HAMPTON INN
LIVERMORE, CALIFORNIA

FOR:
BRAHMA ENTERPRISES, INC.

MARK	DATE	DESCRIPTION
		BUILDING PERMIT SUBMITTAL

LIGHT POLE DETAIL A-A
SCALE: N.T.S.

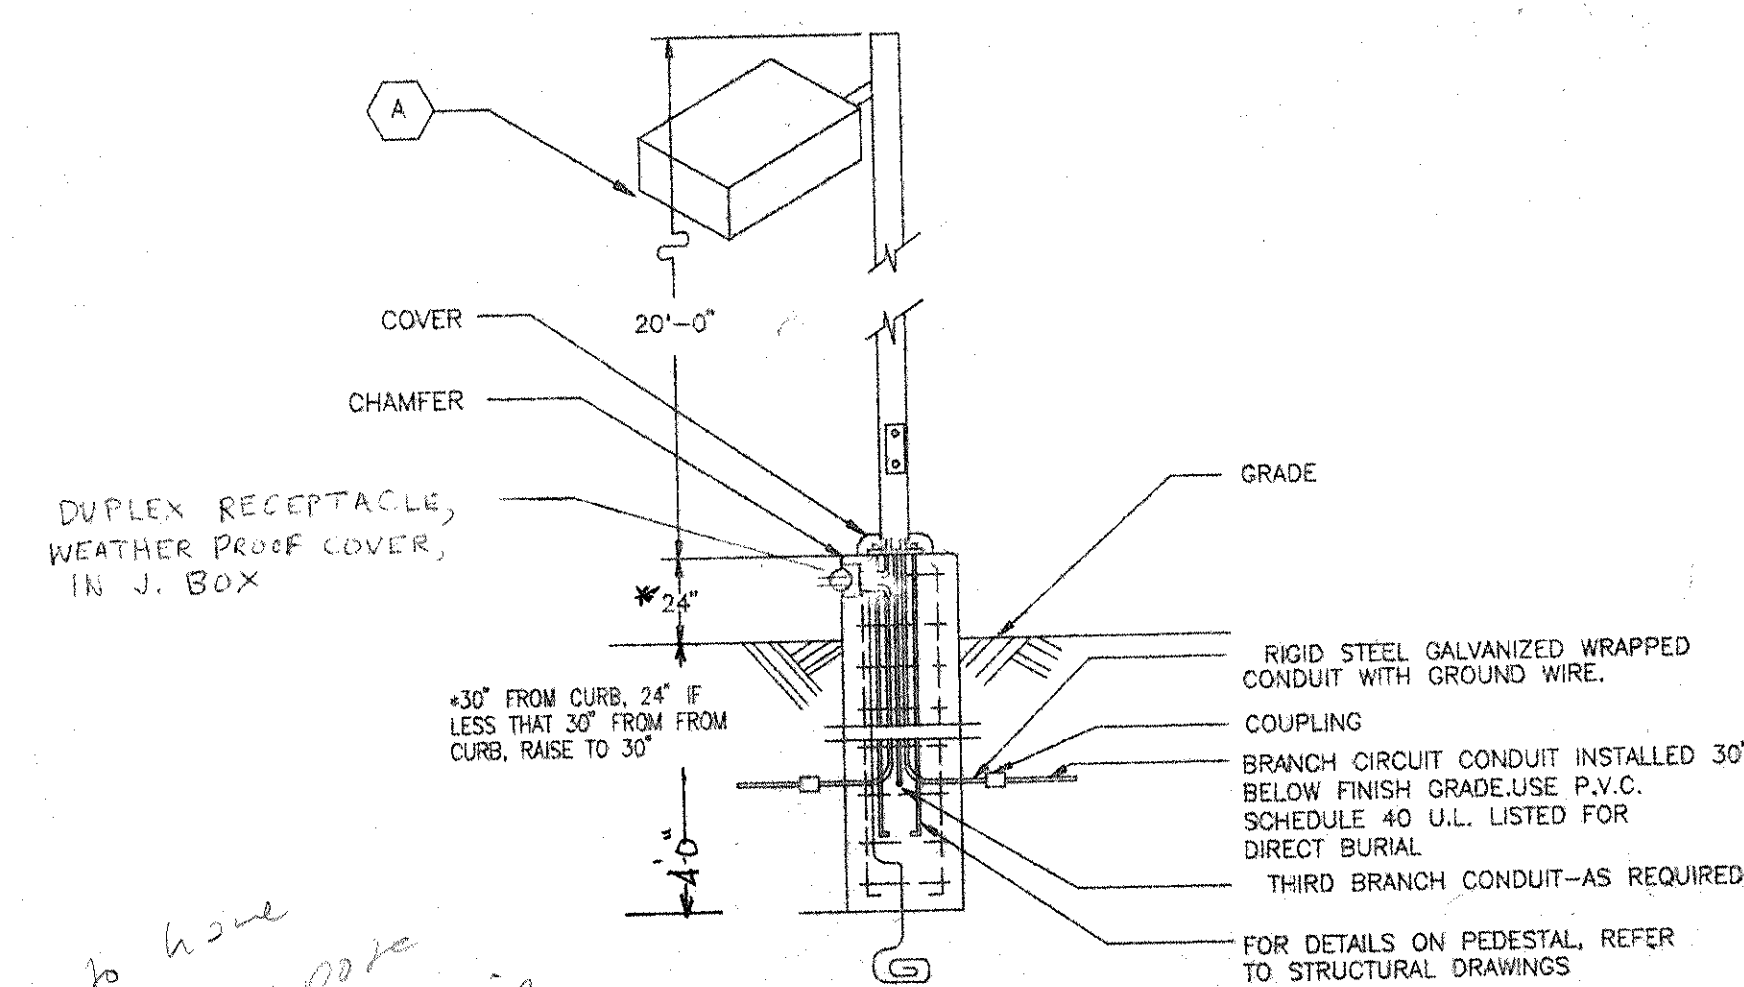
1500 17 2
lights on light pole
Shining up st Building
instead of on ground
What lights on in
canopy

MECHANICAL ROOF PLAN
SCALE: 1/8"=1'-0"

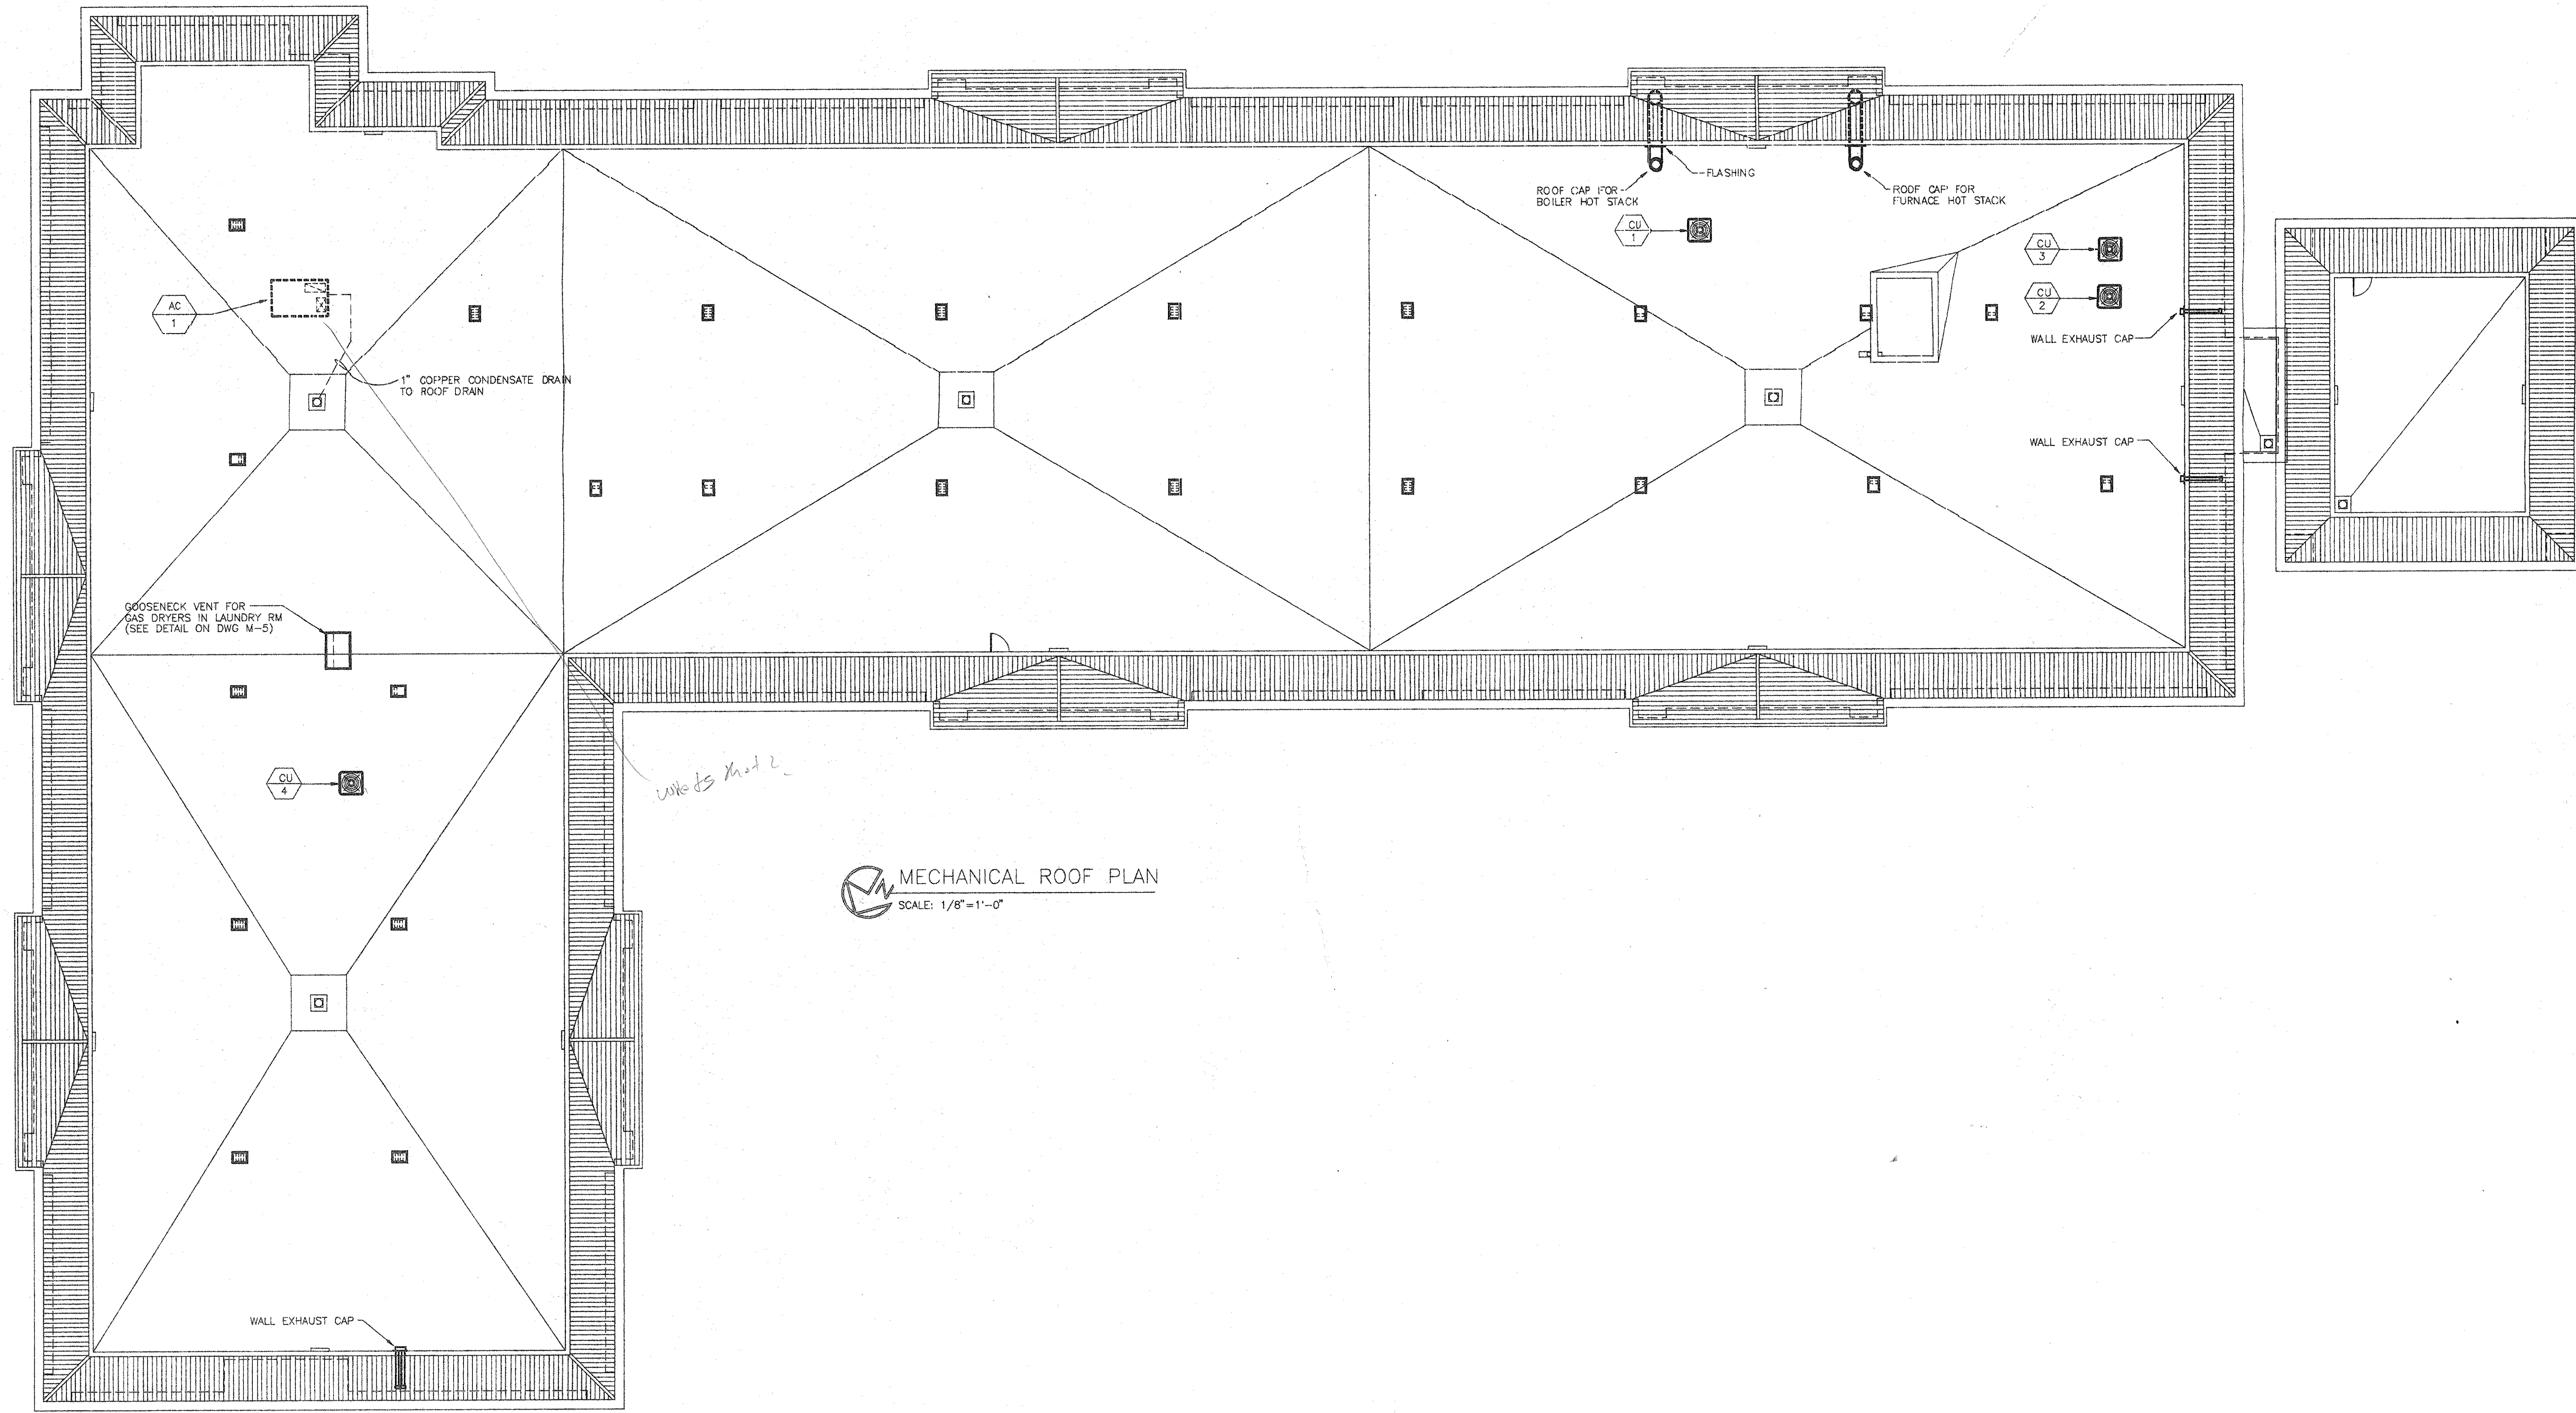
Central units
How many & where?

Units Mod 2

FOR: GRADING AND DRAINAGE

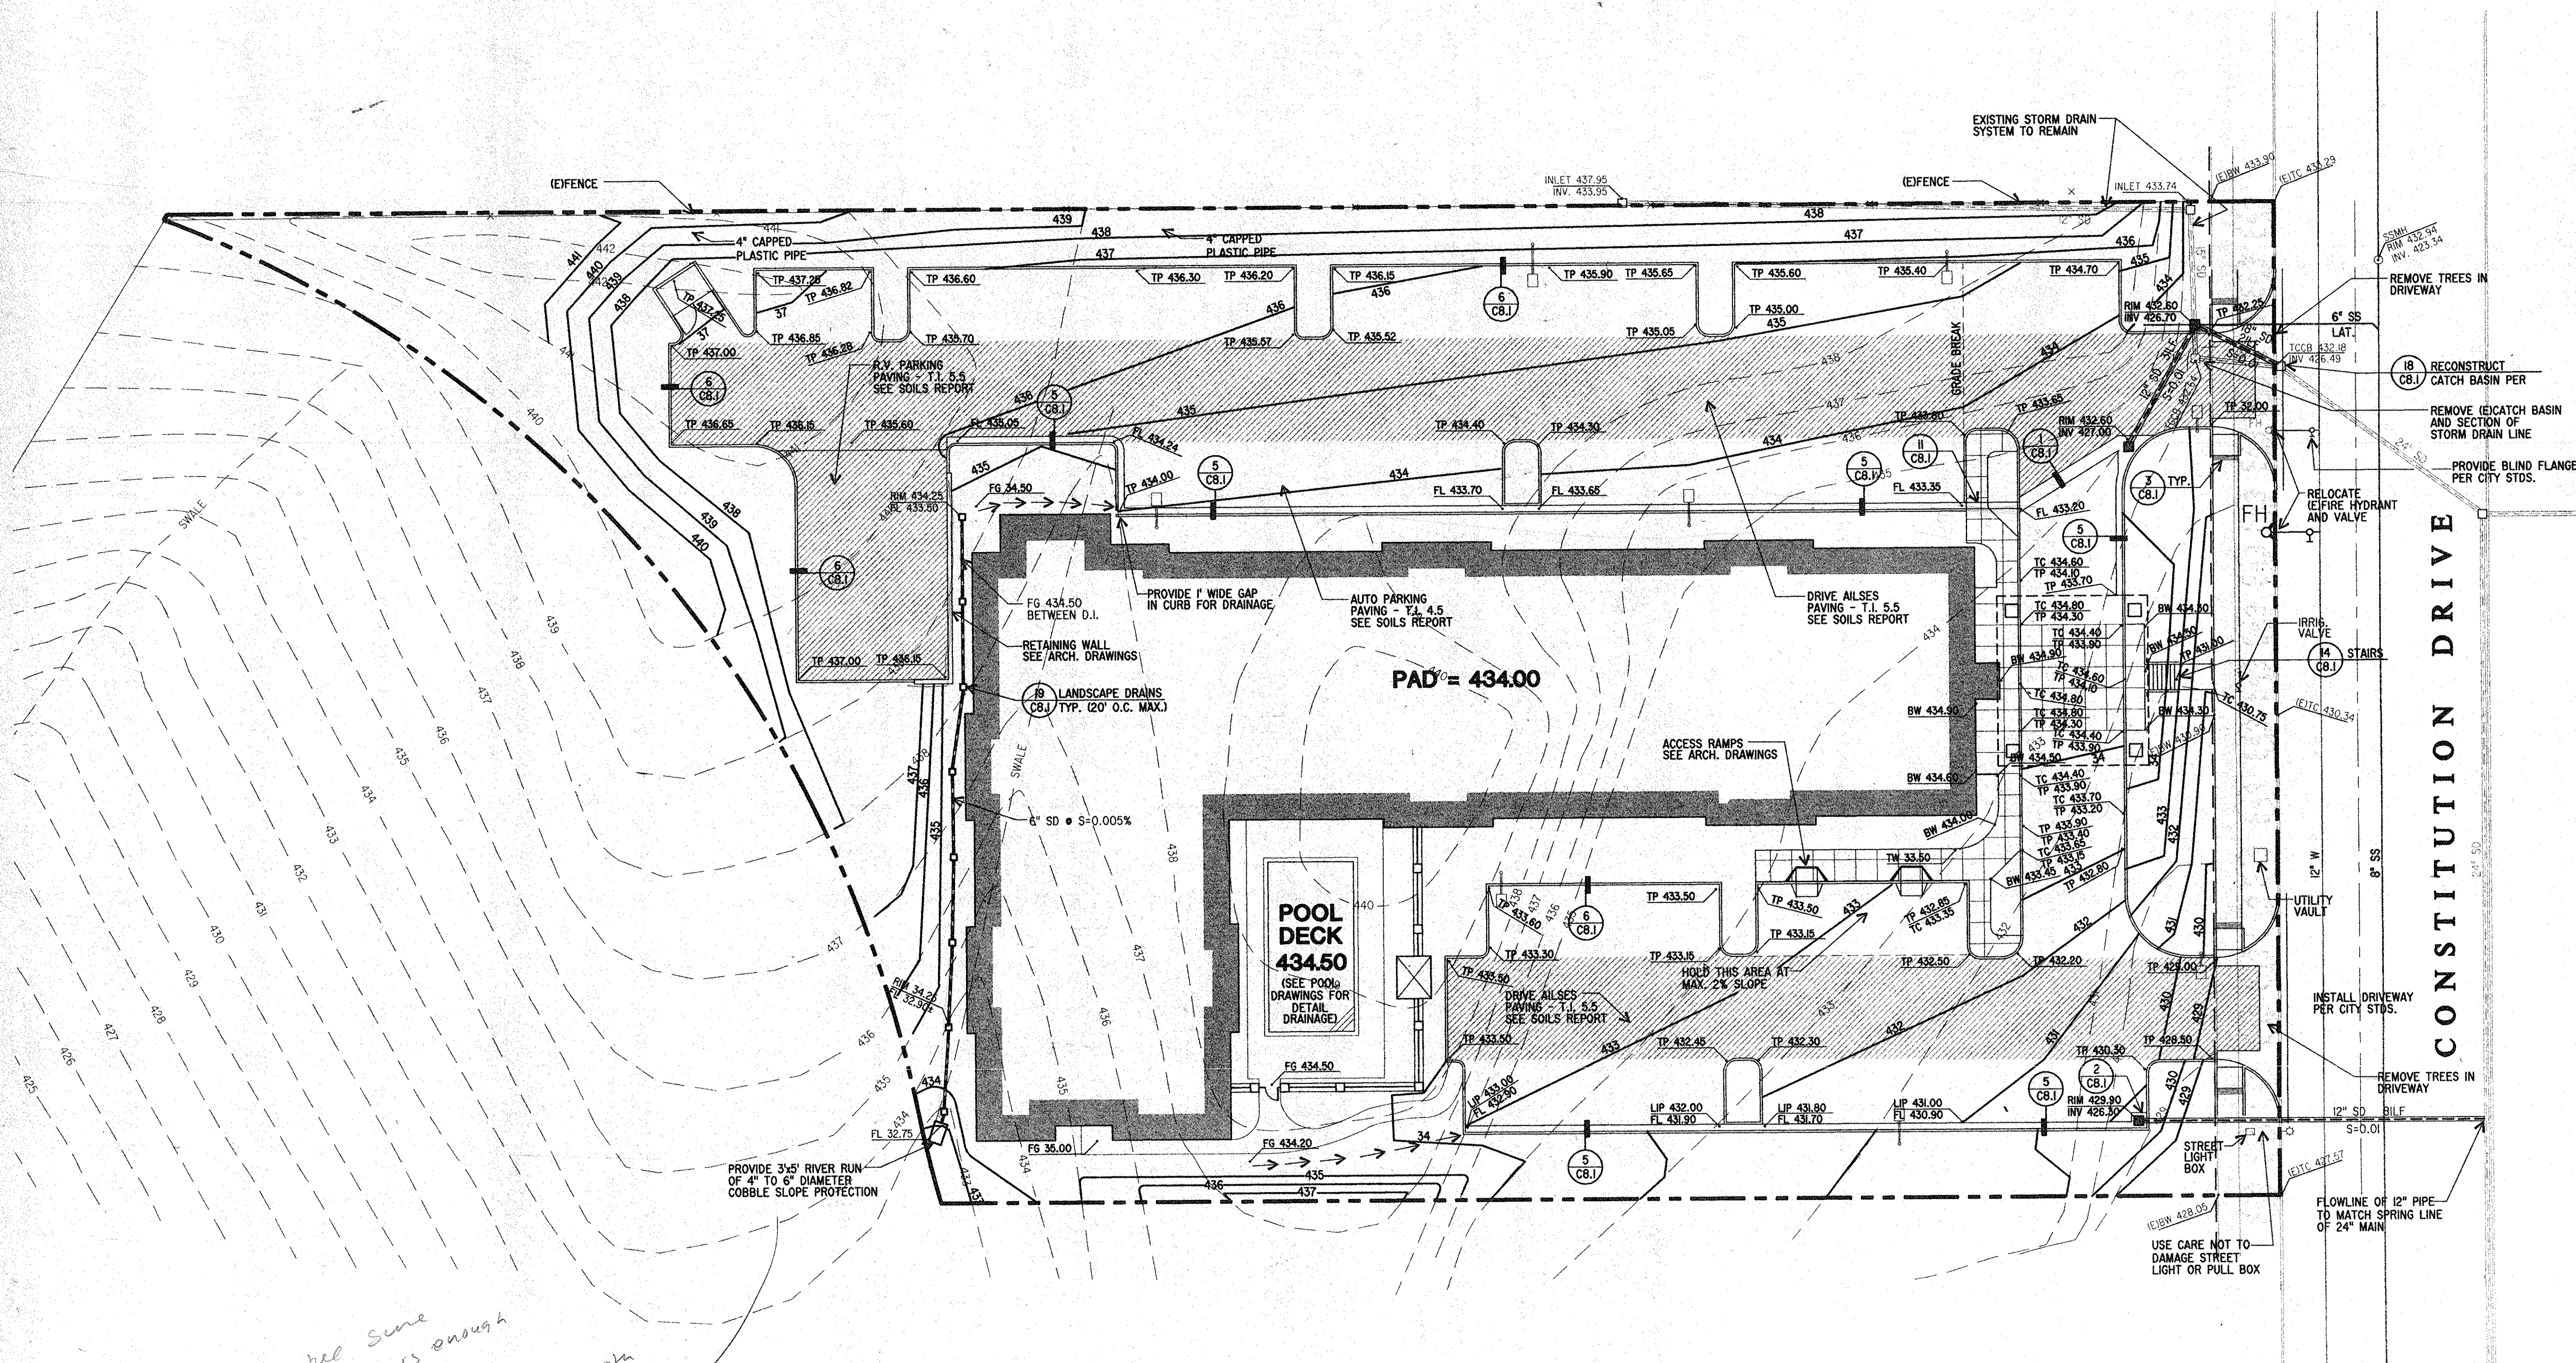
Make sure
not make is enough
slope.
especially on Top North
also in RV Area which is this

EAST ELEVATION
SCALE: 1/8"=1'-0"

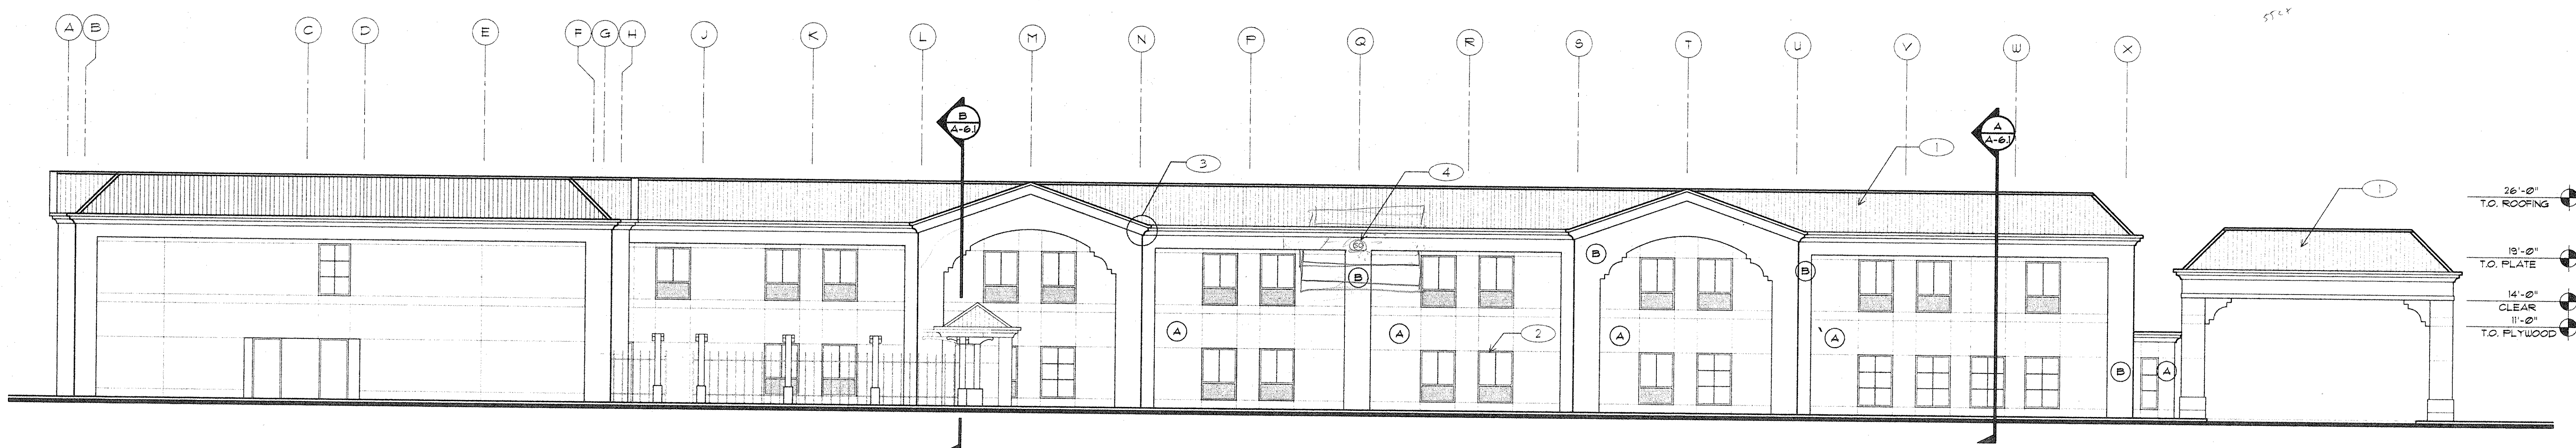
How high is
signage on walls
Ask Sign guy site
